HEAT PUMP SYSTEM
A.C. DAVIS HIGH SCHOOL

July 1980

ADDENDUM

The following is a reply to the questions raised by the R. S. Cameron Company in its August 15, 1980 "Report on Geothermal Report".

FIGURE #2
GEOETHERMAL WATER DISTRIBUTION SYSTEM

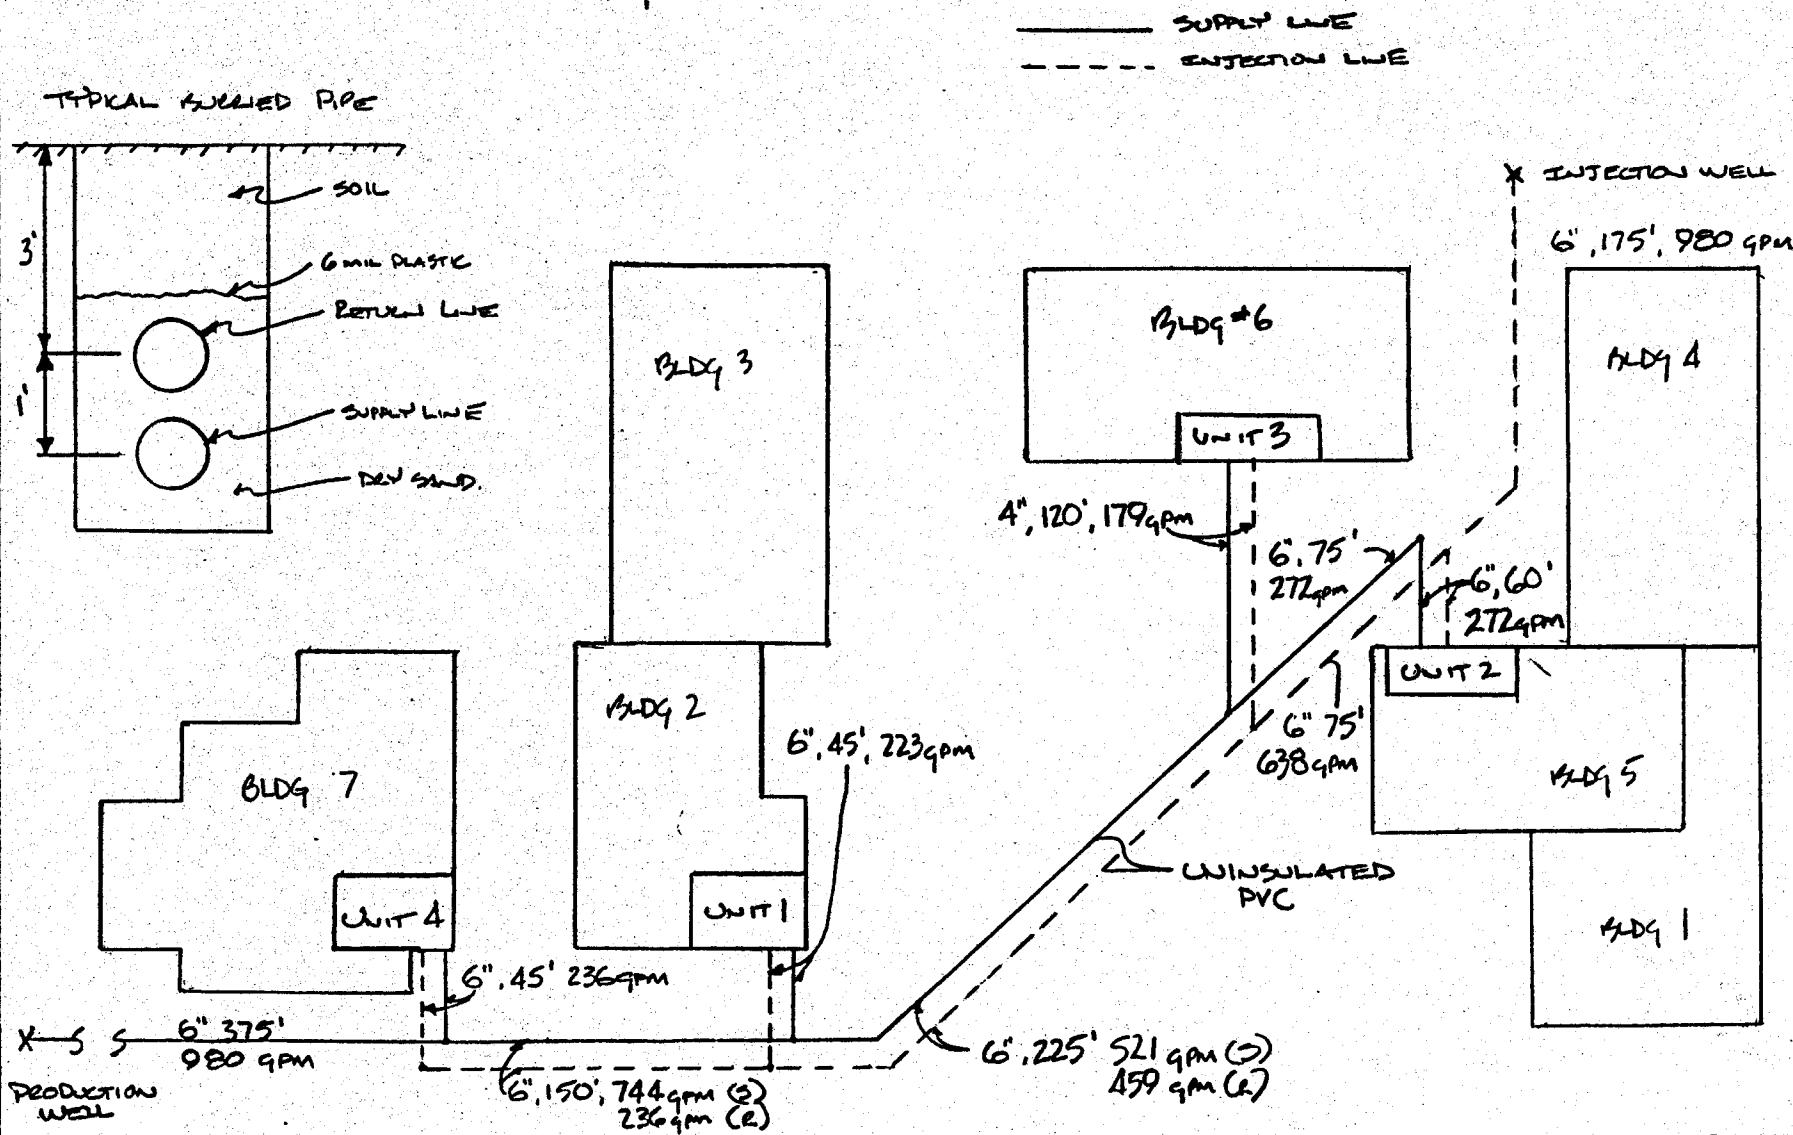
4. The proposed distribution system does not appear to be feasible in that some of it cuts across the existing court and it is necessary to cut up the existing concrete retaining walls, steps, fountain and court yard. We believe that this line will be routed around the outside of the property and must meet requirements for construction imposed by the City Engineering Department, thus rendering the use of plastic pipe questionable.

Item 4, Page 2. Distribution System. After visiting the campus, it was obvious that the originally proposed piping system was not a workable design. The attached diagram (Appendix D) indicates the new routing of geothermal delivery mains. The lines could be installed under the sidewalks and grass areas between the buildings and the street. Conversations with the Yakima City Engineer have indicated that Schedule 40 PVC pipe is permissible in this type of installation.
